ATTACHMENT A

KENWOOD COMMUNITY & SENIOR CENTER ATTACHEMENT A

ADDENDUM #1 – REVISED DRAWINGS

S3.12

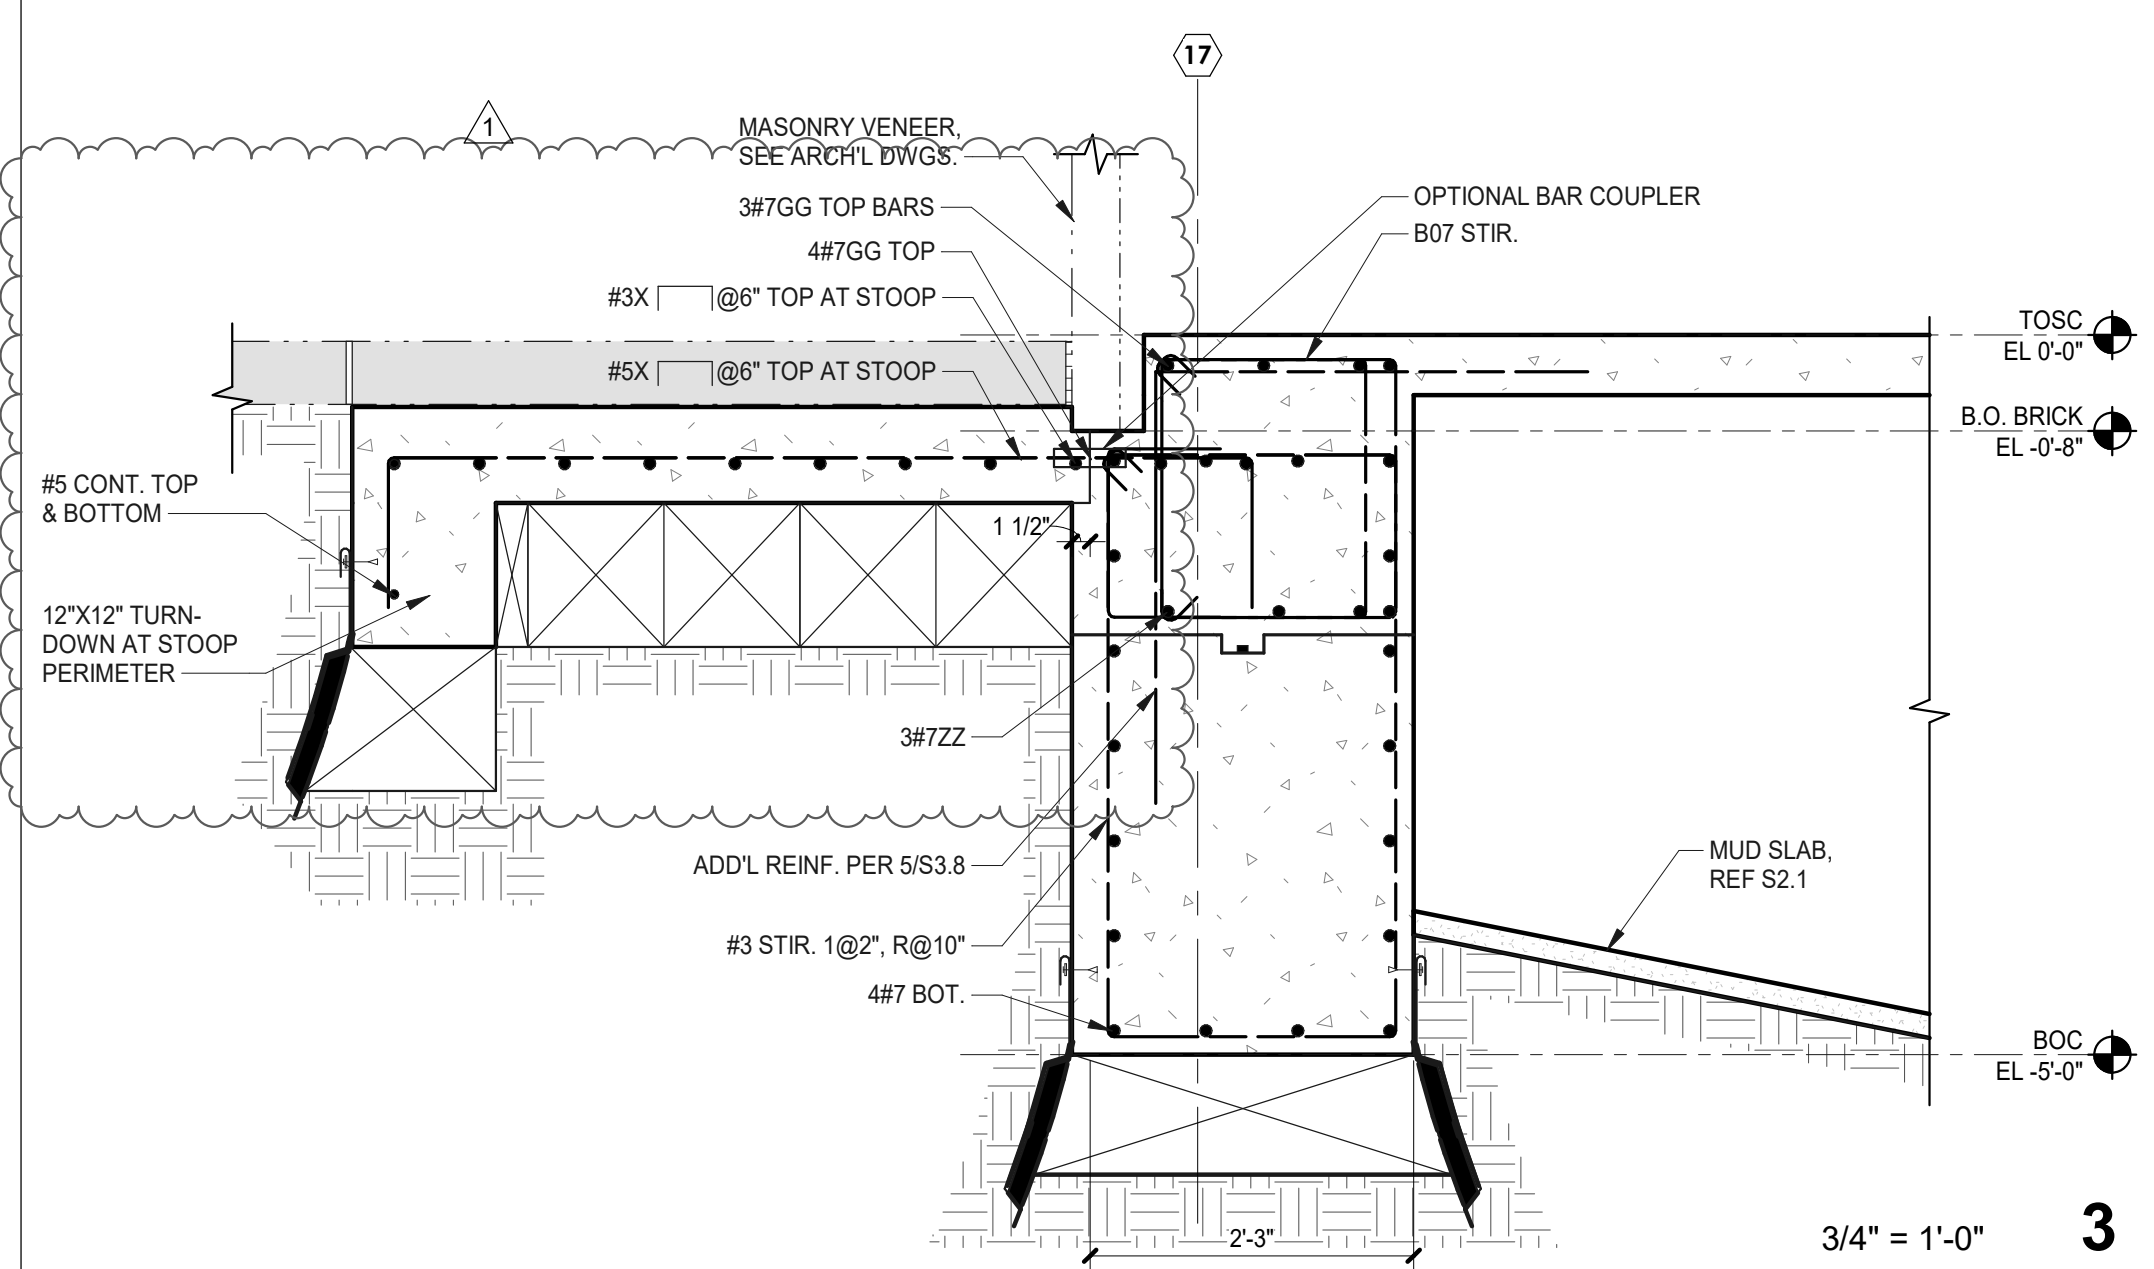
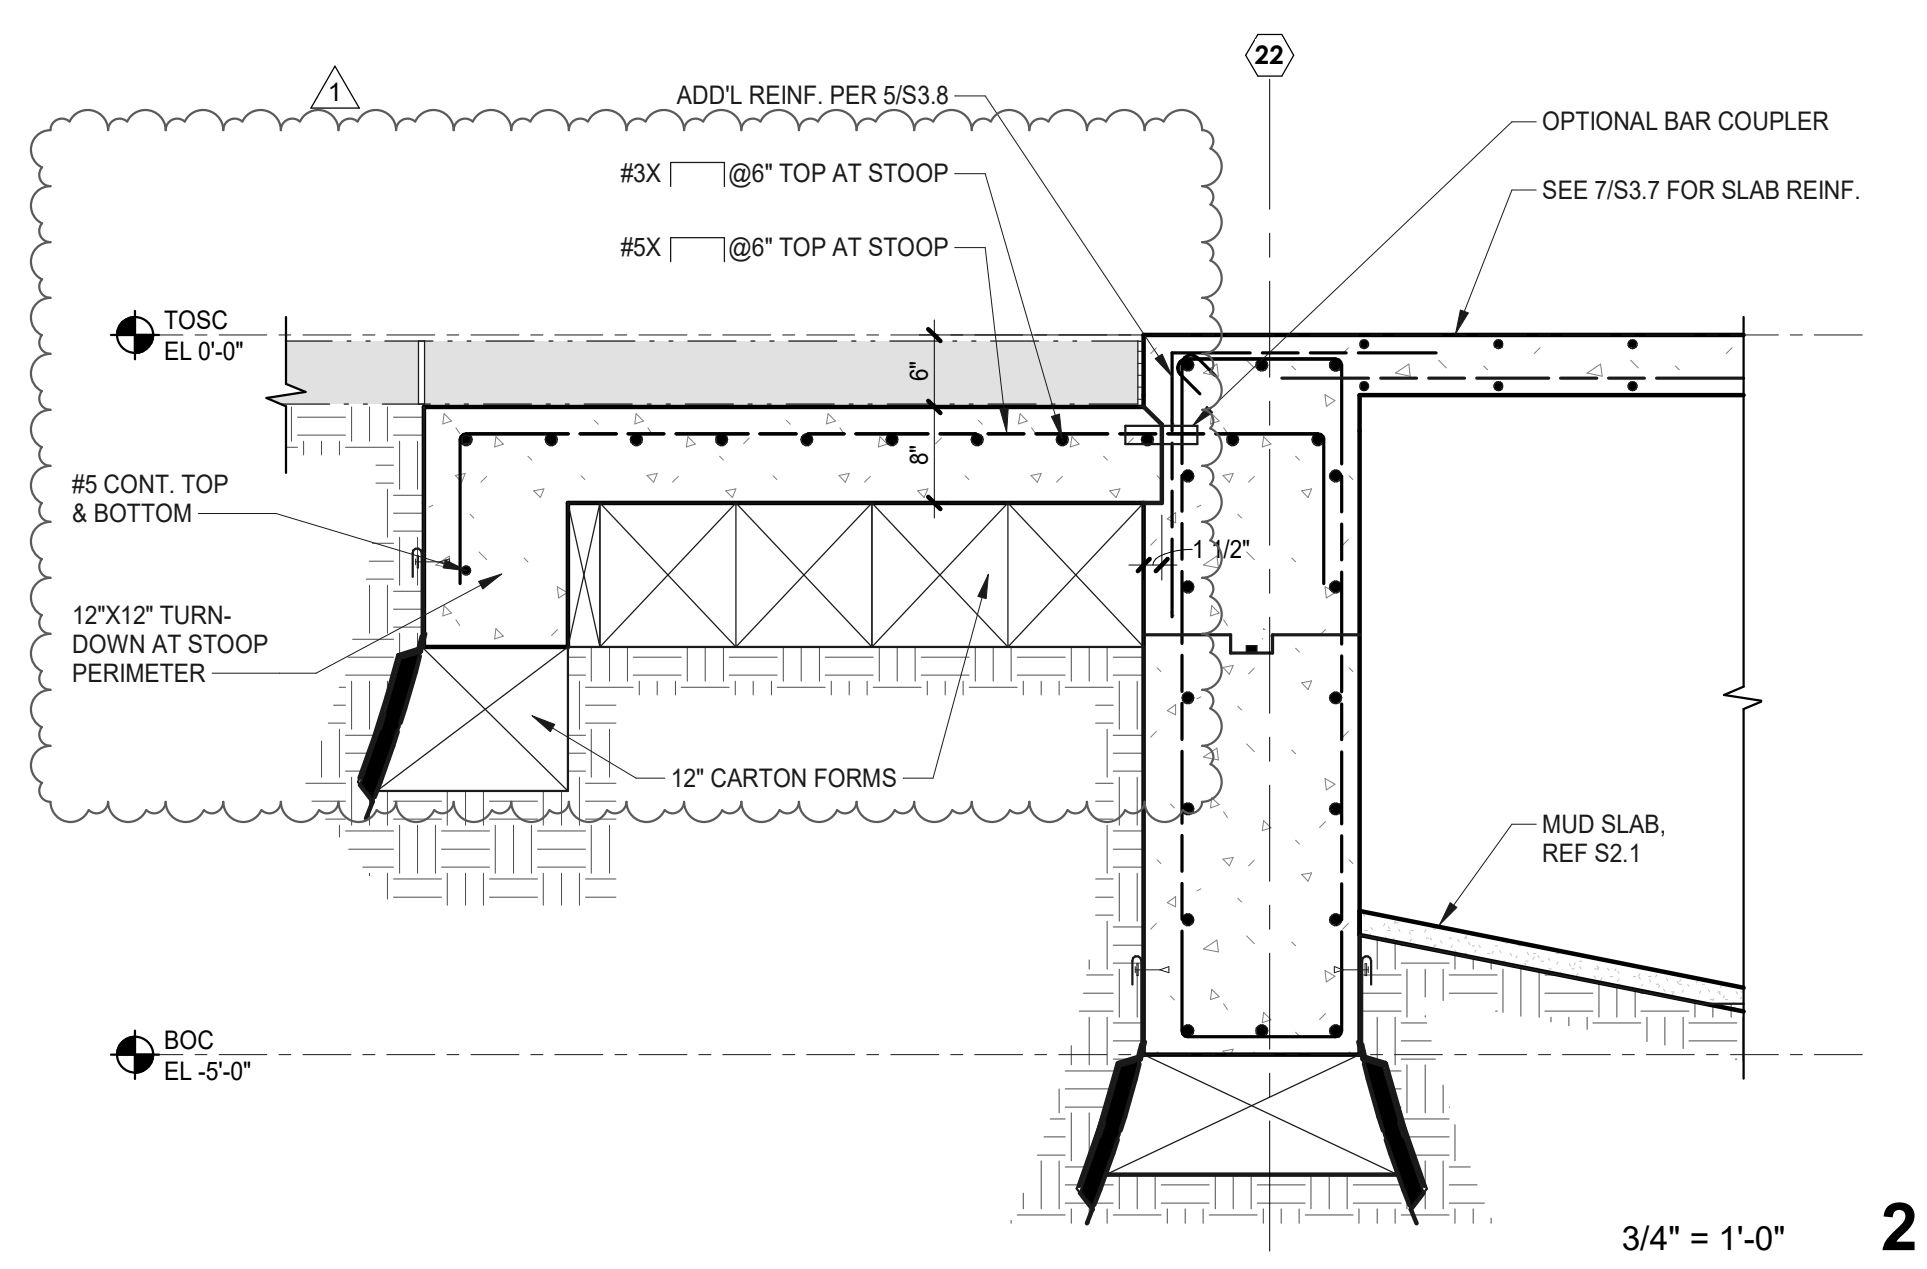
The roughened concrete has been replaced with a bond breaker to improve crack control, refer to attached revised sheet S3.11 & S3.12

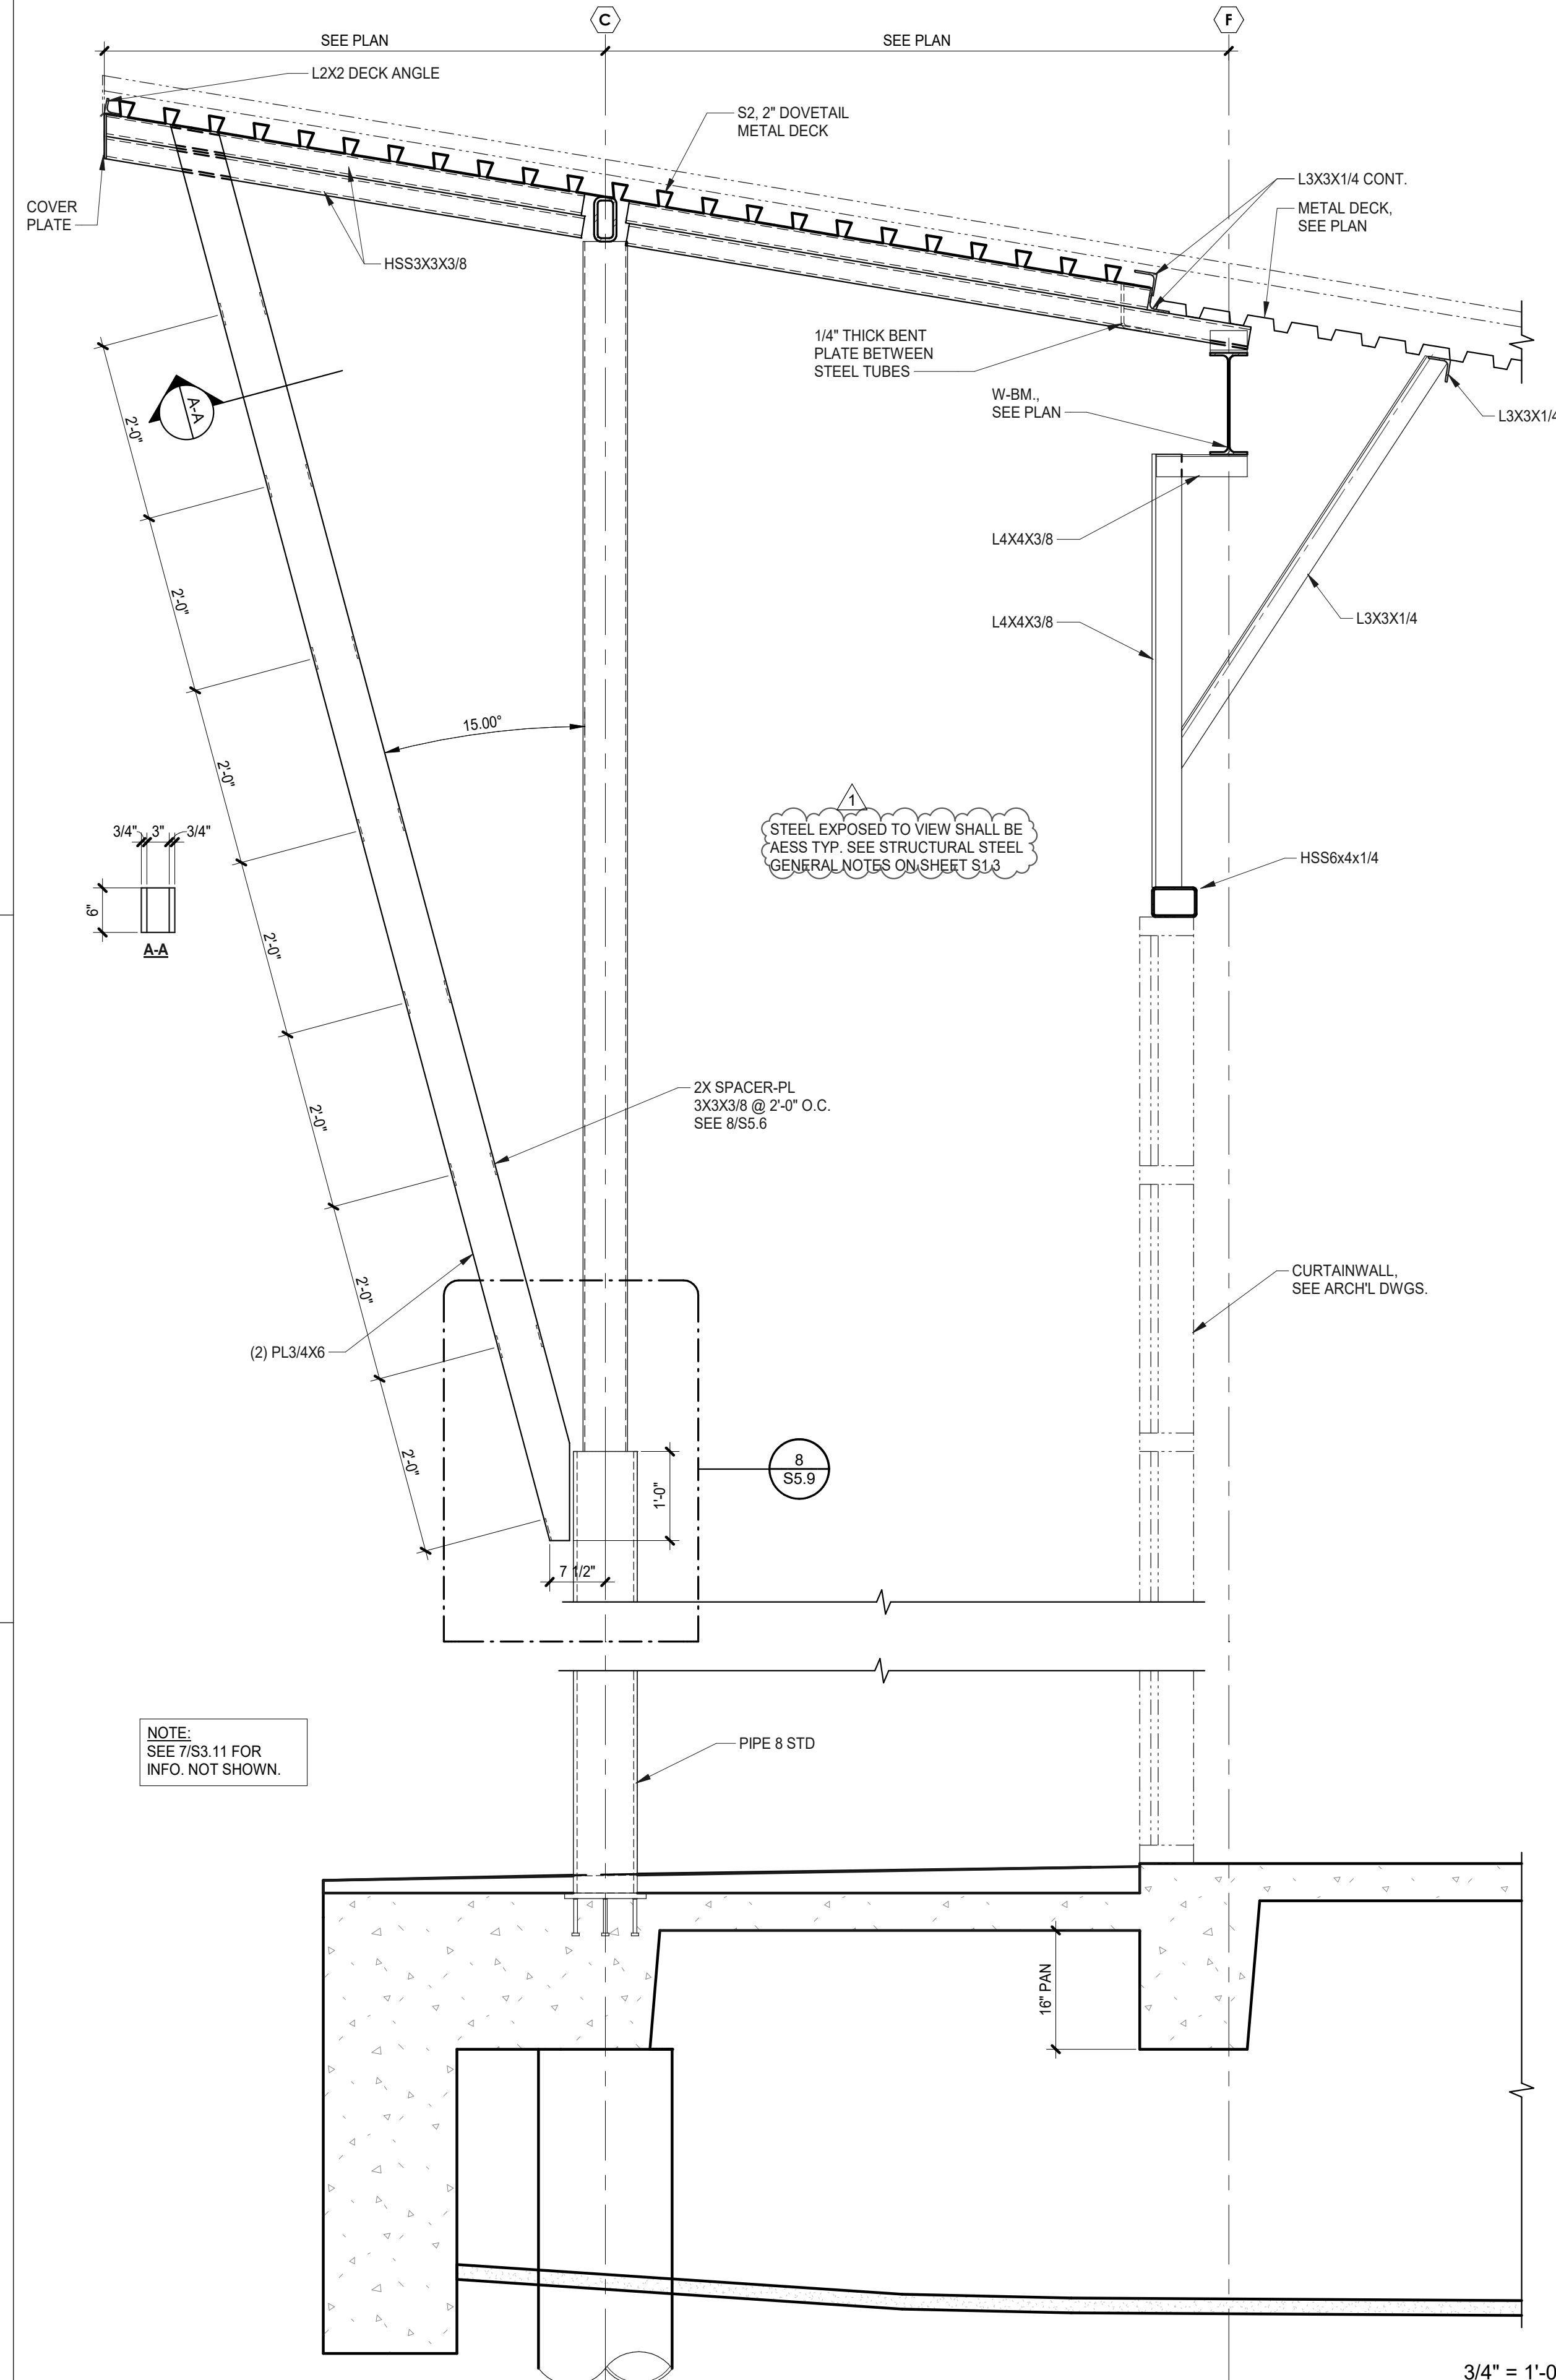
AESS requirements and AESS category matrix have been added to the project, refer to attached revised sheets S1.3, S5.11, & S5.13.
